Tesla, Inc.
Service Bulletin

Inspect 1st Row Seatback Fastener Torque

SB-25-13-003
June 25, 2025

Figure 1 – LH and RH seats similar; inboard and outboard bolts similar

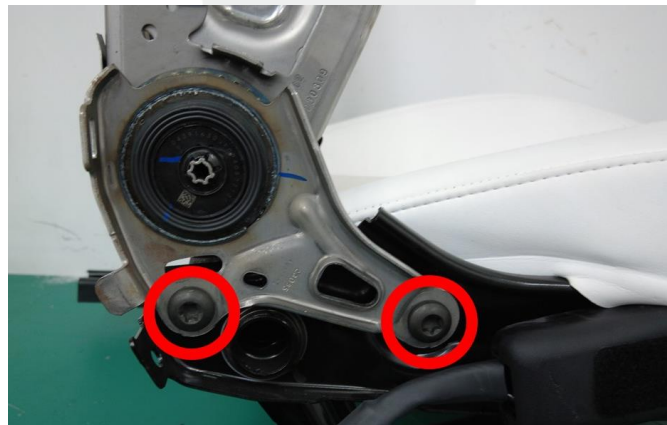
Some Model 3 and Model Y vehicles may have been built with improperly torqued fasteners that attach the 1st row seatback to the seat cushion.

1. Remove the LH 1st row seat assembly and place it on a clean and stable working surface. Refer to Service Manual procedures:
 - Model 3: [1304010022](#)
 - Model Y: [1304010402](#)
2. Remove the inboard and outboard side shields from the front seat assembly that was removed:
 - Model 3
 - Inboard Side Shield: Service Manual procedure [1307010132](#)
 - Outboard Side Shield: Service Manual procedure [1307010122](#)
 - Model Y
 - Inboard Side Shield: Service Manual procedure [1307010302](#)
 - Outboard Side Shield: Service Manual procedure [1307010502](#)
3. Remove the inboard and outboard side shield carriers from the front seat assembly that was removed (refer to Service Manual procedure 1307010022; [Model 3](#), [Model Y](#)).
4. Perform a torque check on the inboard and outboard bolts (**x4 total**) that attach the seatback to the seat cushion (torque 43 Nm) (Figure 1).

- If a bolt is already properly torqued, take note.
- If a bolt is under-torqued, remove and discard the bolt, and then replace it with a new bolt. Take note of this action.

⚠ CAUTION: Replace all under-torqued bolts. DO NOT re-use any under-torqued bolts.
